915 PREAMPLIFIER CIRCUIT SCHEMATIC
MAIN PC BOARD AND CHASSIS

REVISED 11/6/91

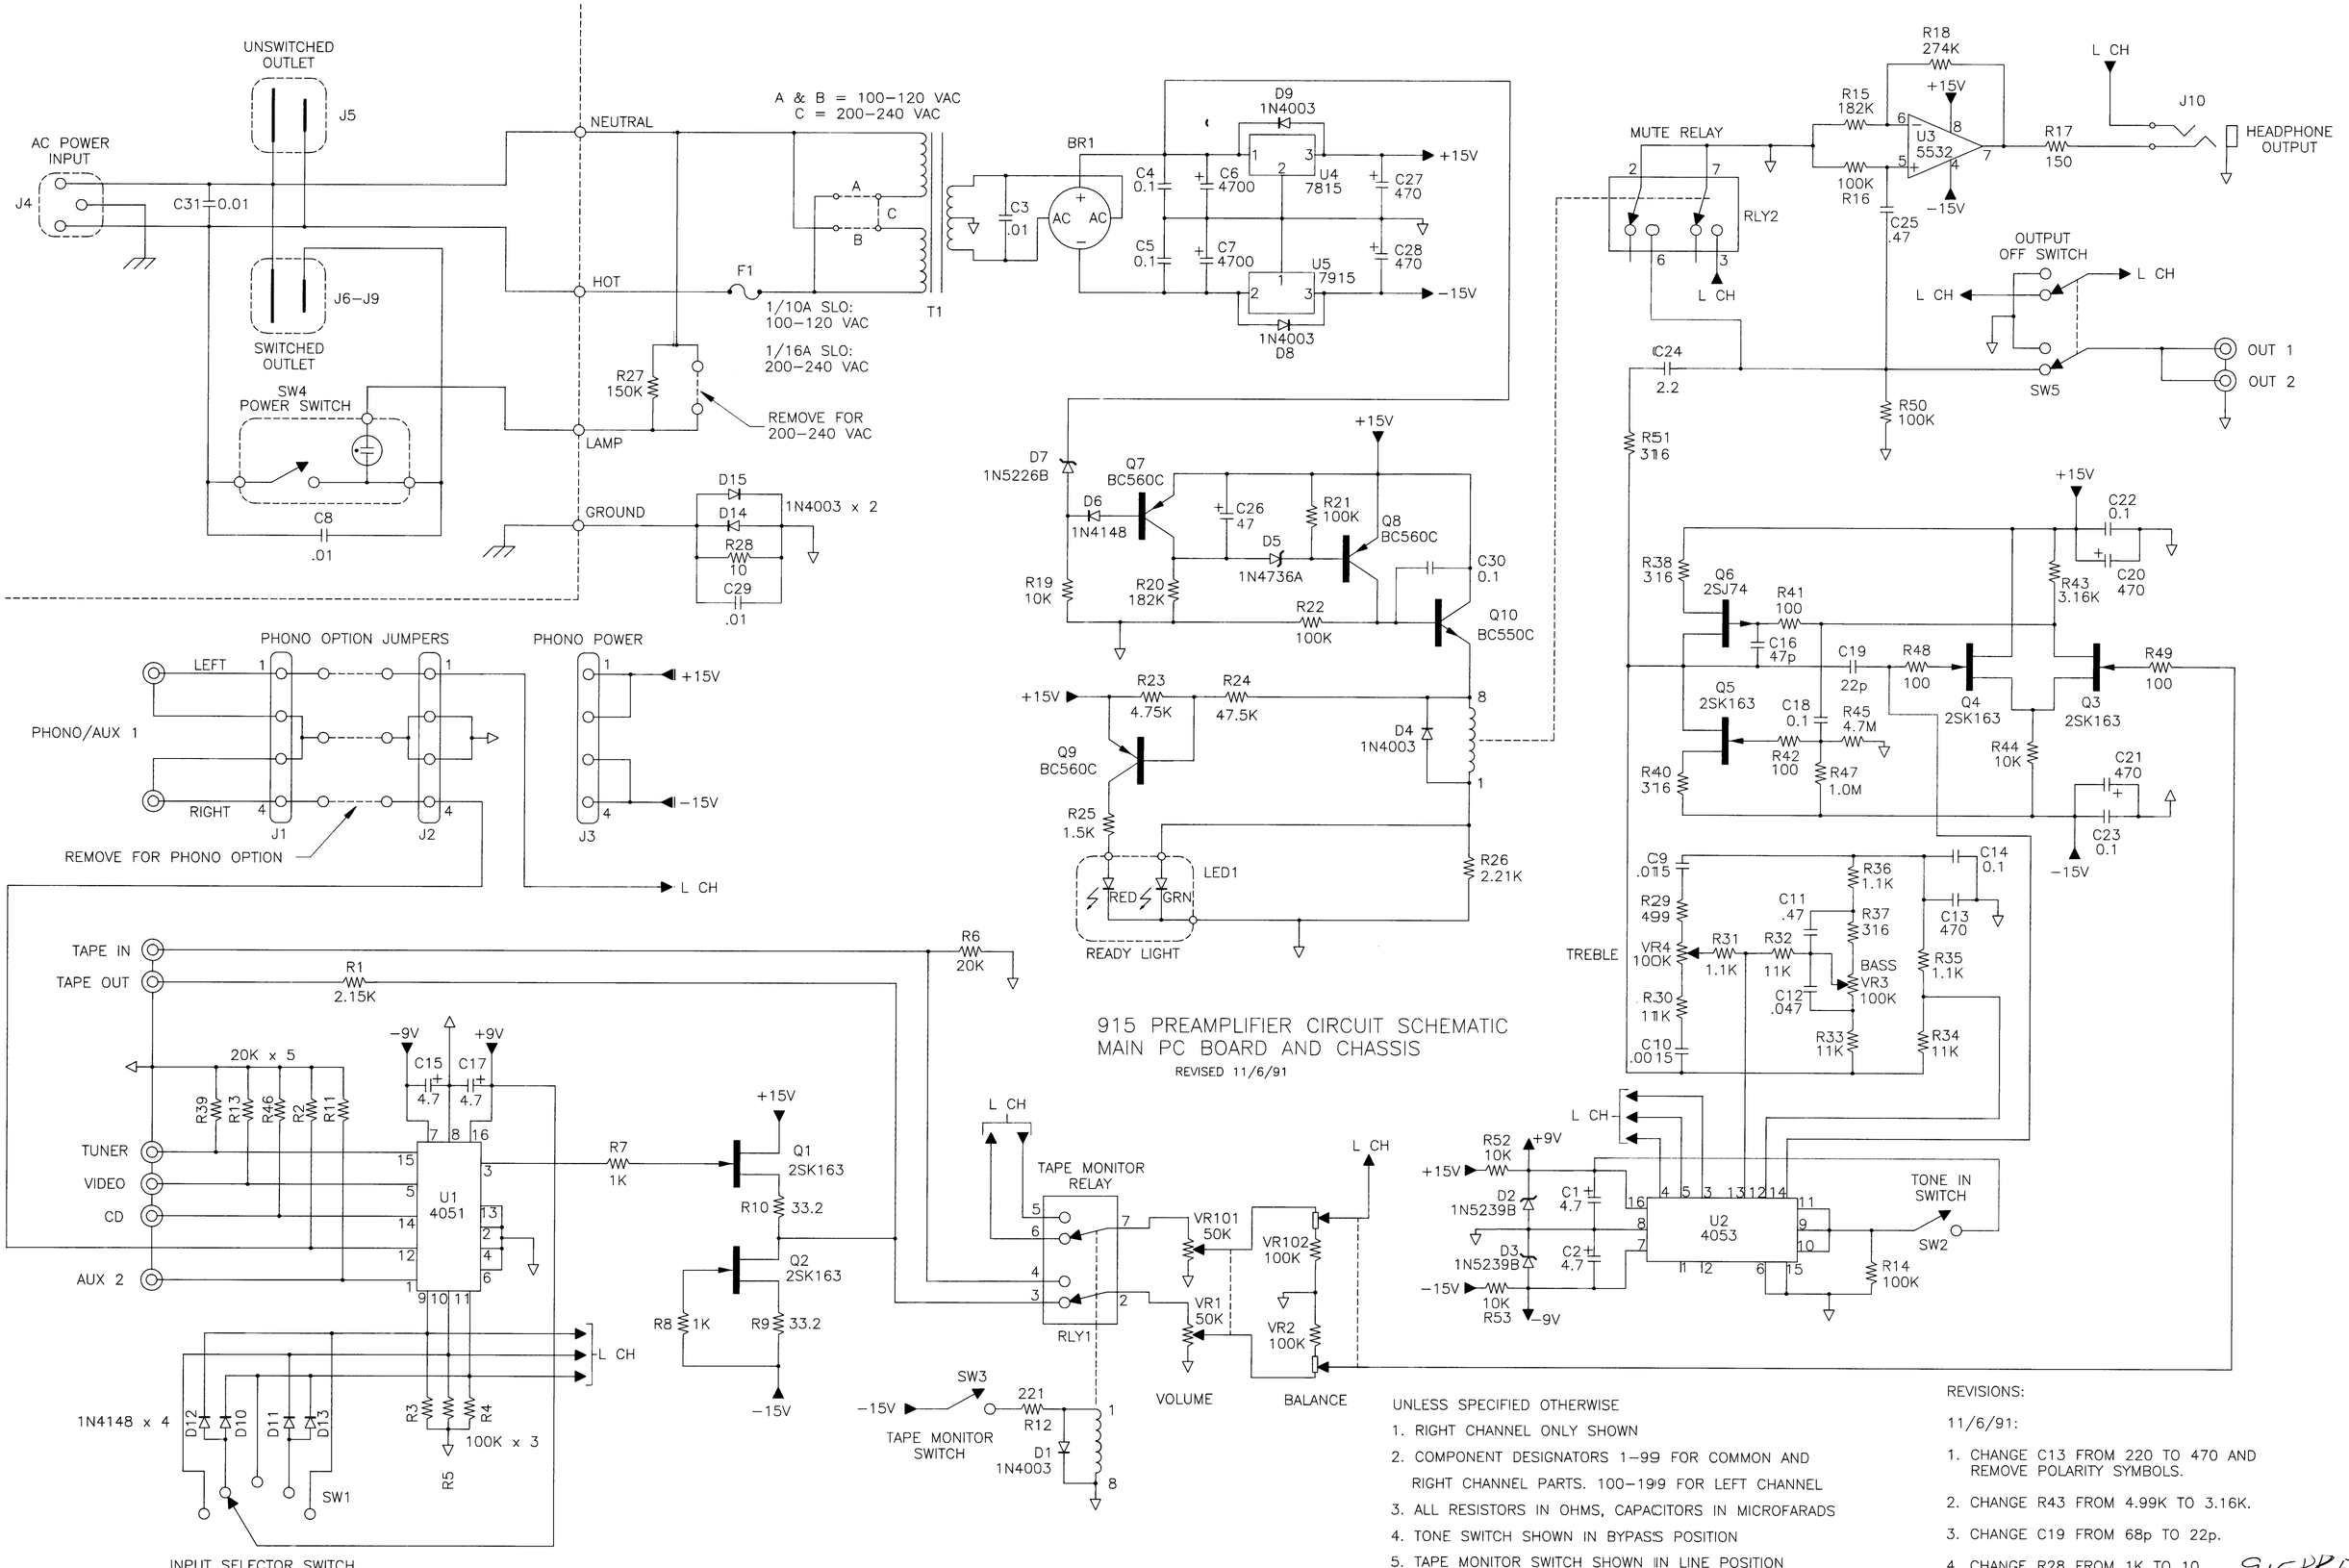
1. CHANGE C13 FROM 220 TO 470 AND REMOVE POLARITY SYMBOLS.
2. CHANGE R43 FROM 4.99K TO 3.16K.
3. CHANGE C19 FROM 68p TO 22p.
4. CHANGE R28 FROM 1K TO 10.
5. ADD C31, 0.01.
